Re: Interpretation for SPA 87-S-012-3, Rajdhani Mandir: Limits of Clearing and Grading, Open Space, Retaining Wall

**Re: Rajdhani Mandir Religious Center – SP #07271-SP-002
Special Permit Amendment Application No. SPA-87-S-012-03
4525 Pleasant Valley Road, Chantilly, Va. 20151**

Subject: Plan Control Number 7271-SP-002
Various Site Plan Submissions to Accommodate Additional Parking, Storm Drainage
Easement Requirements, Trail Connection

**GENERALIZE DEVELOPMENT PLAN
 RAJDHANI MANDIR
 ADDITIONAL PARKING**

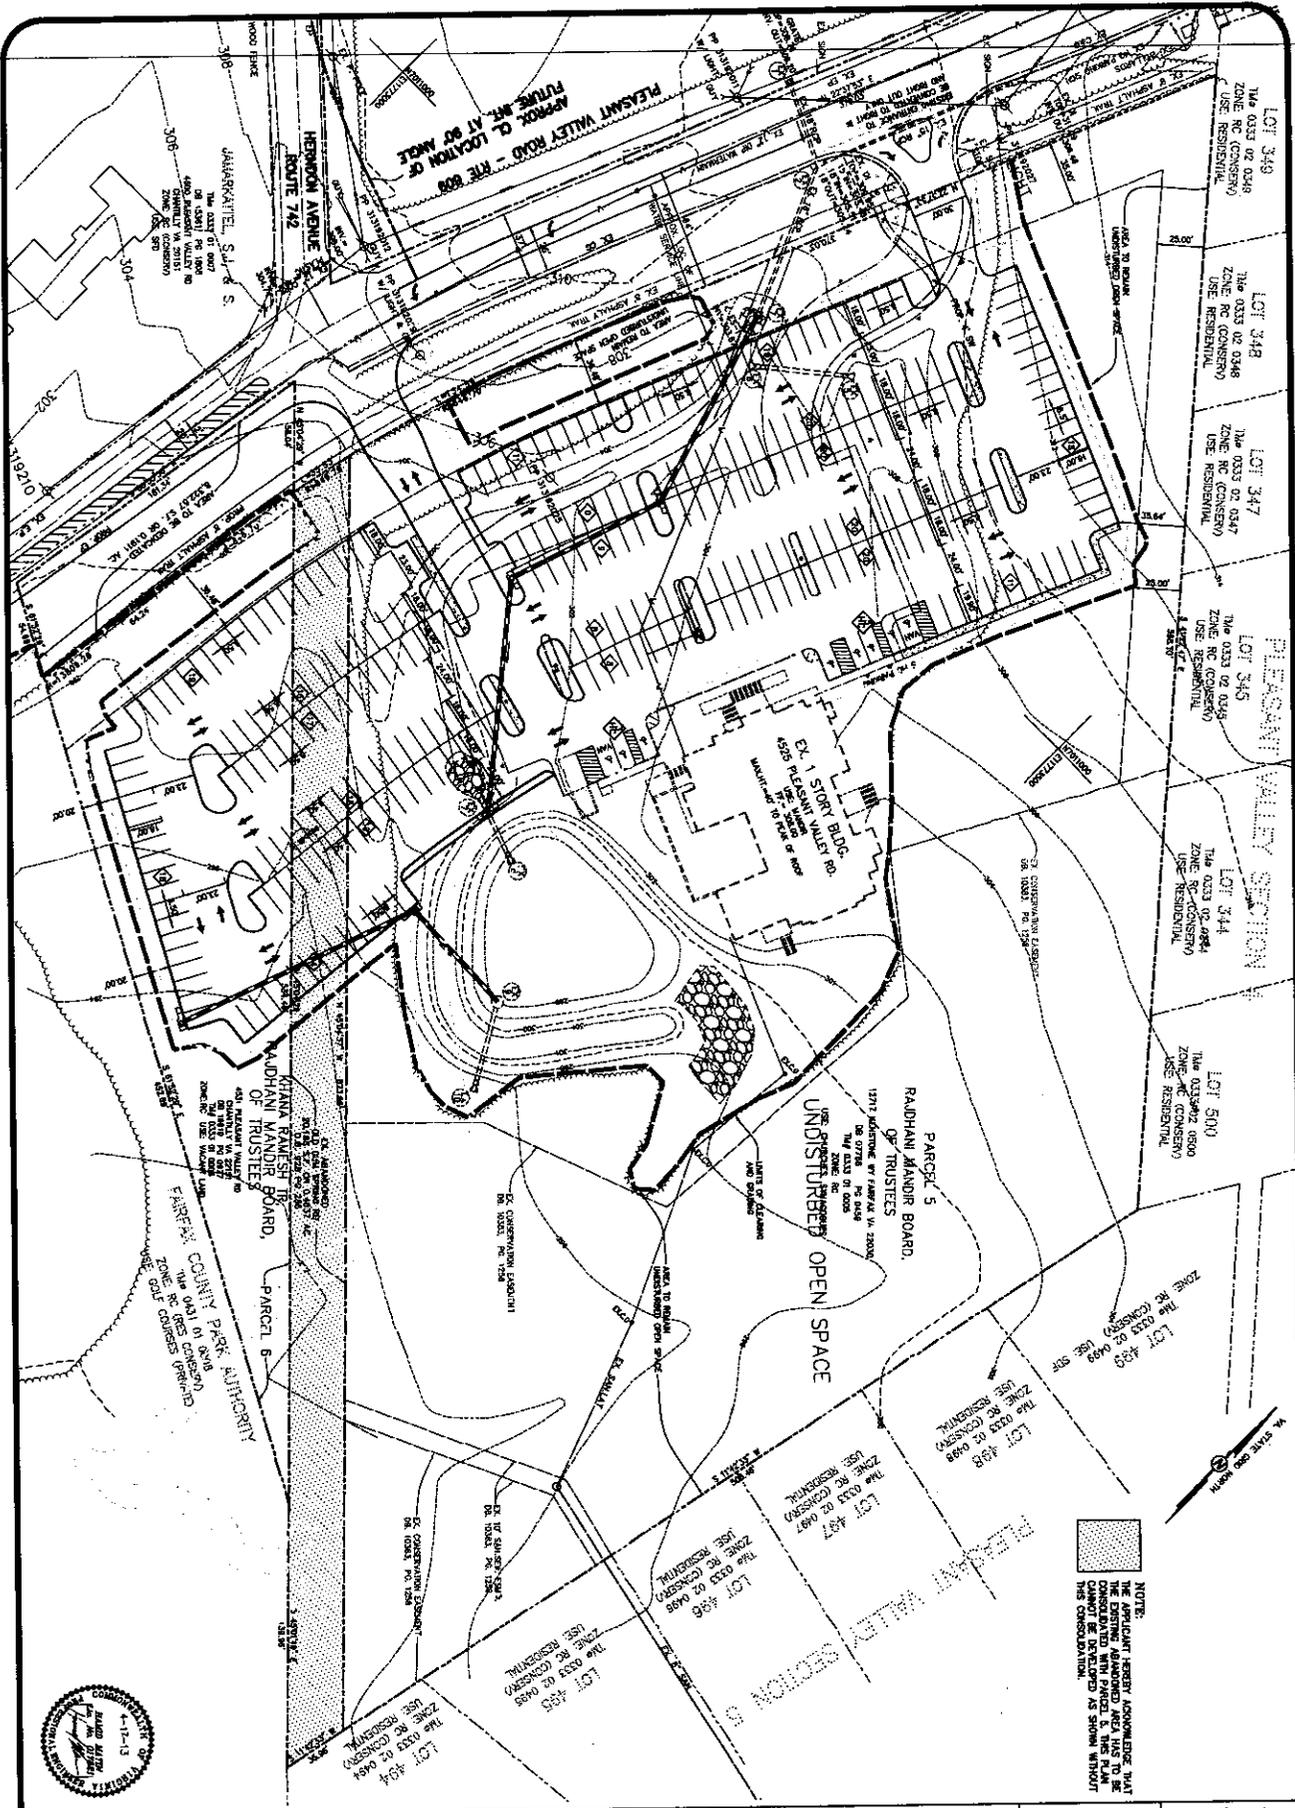
In both of these cases, we are required to grade in an outfall ditch from the existing outfall pipe structure # EX 10 at the SWM facility to the end of our property as shown with the attached site plan sheets 4 and 5. It is necessary to do this to meet county outfall requirements. As a result, we need to add a 26' storm drain easement and have to re-adjust the limits of clearing and grading as well. Please note that we have incorporated the new limits of clearing grading into GDP from the site plan to highlight the differences for your review (Please see attached GDP).

above, we are grading out a drainage ditch to convey the water from the SWM facility. The total area being disturbed outside the limits of clearing and grading shown on GDP is 2670 square feet.

It is my determination that the proposed clearing, grading and open space would be in substantial conformance with the SPA Plat and development conditions, provided that a minimum of 50% of the site is maintained as undisturbed open space, subject to final approval by DPWES and FCPA. It is also my determination the proposed retaining wall would be in substantial conformance with the SPA Plat and development conditions, subject to final approval by DPWES. These determinations have been coordinated with DPWES and FCPA, have been made in my capacity as duly authorized agent of the Zoning Administrator, and only address the issues discussed herein.

EXHIBIT SHOWING DITCH MEANDERING THROUGH PARK TREES

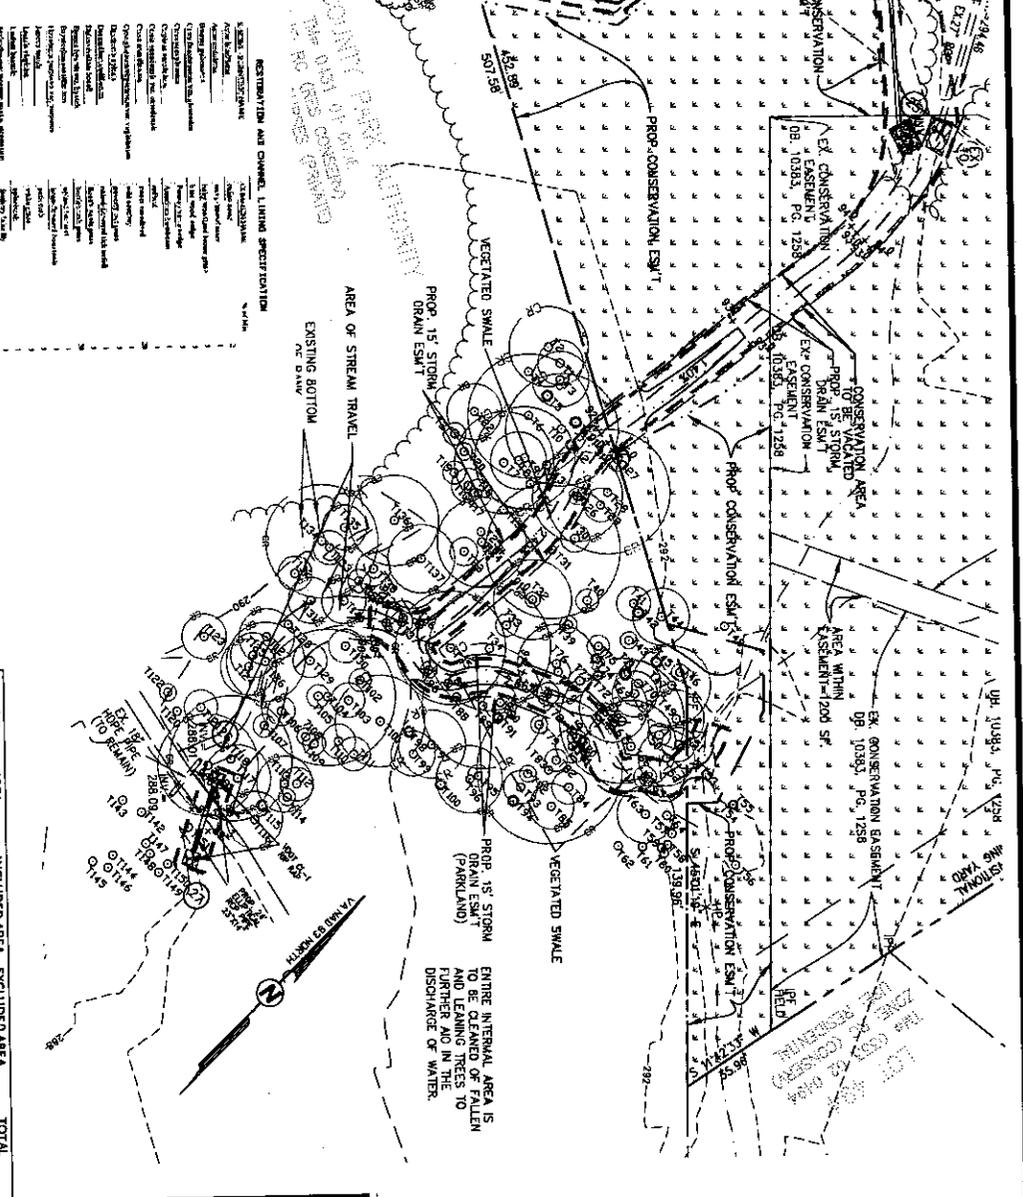
In regard to out fall as shown on revised plans, please note that we had several meetings with Ms. Cynthia E. McNeal and Ms. Patricia Rosend of Fairfax County Park Authority Staff to discuss the permission to grade offsite onto their property to provide beds and banks for outfall as requested. The final decision was that the Park Authority will grant the permission, licenses and easements required if the Department of Land Development Services review and approve the outfall. Per our meeting today we are providing additions computations for meeting Park Authority requirements and will be working on getting permission and easements from Park Authority to construct the additional out fall channel as shown on our plans.

The Park Authority has field inspected and documented the existing conditions of the Richard Jones Park adjacent to the Applicant's site. The Park Authority has deemed the existing conditions as stable and healthy. The Park Authority has evaluated the proposed stormwater design and understands that the fifteen (15) feet wide storm drainage easement is necessary per County regulations. The tree valuation process is in progress with the Applicant and all trees within the easement on parkland will be considered in the assessment of tree impact per County requirements. The Park Authority restoration specifications were previously provided to the Applicant and the Park Authority requested that they be included with the site plan insert sheets. The restoration specifications are also included with this letter, see Attachment 2.

OVERALL OPEN SPACE AREA PLAN
RAJDHANI MANDIR
 ADDITIONAL PARKING
 SULLY DISTRICT FANFAX COUNTY, VIRGINIA

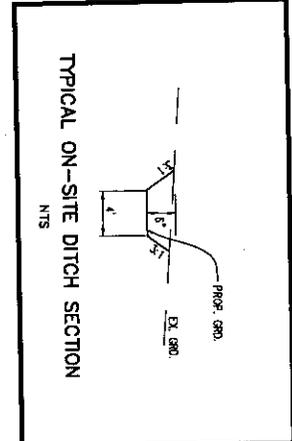
We are submitting this letter of interpretation along with the plans for review and determination for substantial conformance. Per our meeting we have revised the site plan to eliminate the open spaces that are not quality spaces and are not connected to other larger spaces were eliminated from our total open space computations. As result the grading along the southern parking area was eliminated and limits of disturbance was pushed back to achieve additional undisturbed area. This was achieved by providing a retaining wall that has a maximum of height of 7.5 feet that extends below parking surface. The wall is screened by planting and is facing the wooded area of the Park which will not be visible from park land.
